TRANS/WP.29/GRSG/2000/14/Add.1  
28 September 2000

**PROPOSAL FOR A DRAFT CORRIGENDUM TO REGULATION No. 66  
(Strength of superstructure)**

Transmitted by the Expert from the Czech Republic

Note: The text reproduced below was prepared by the expert from the Czech Republic in order to update his proposal. The proposed amendments refer to document TRANS/WP.29/GRSG/2000/14.

"Figure 1

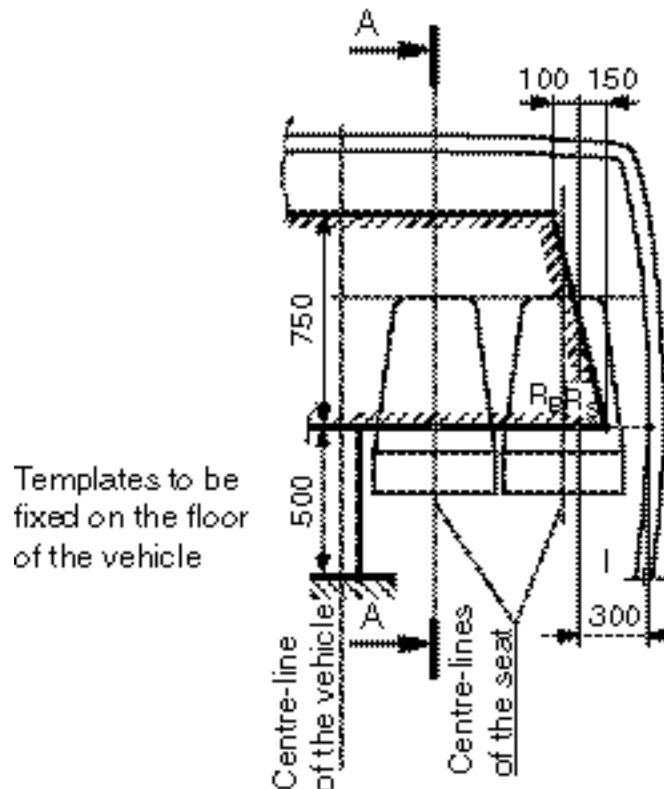
" .... of the vehicle side-wall. The point of these two which defines the widest residual space, shall be taken as decisive for its size in form of a trapezoid of 750 mm height (take - 100 mm for its upper corner, and + 150 mm for its lower corner), see figure 1(a)."

Figures 1(a) and 1(b), amend to read:
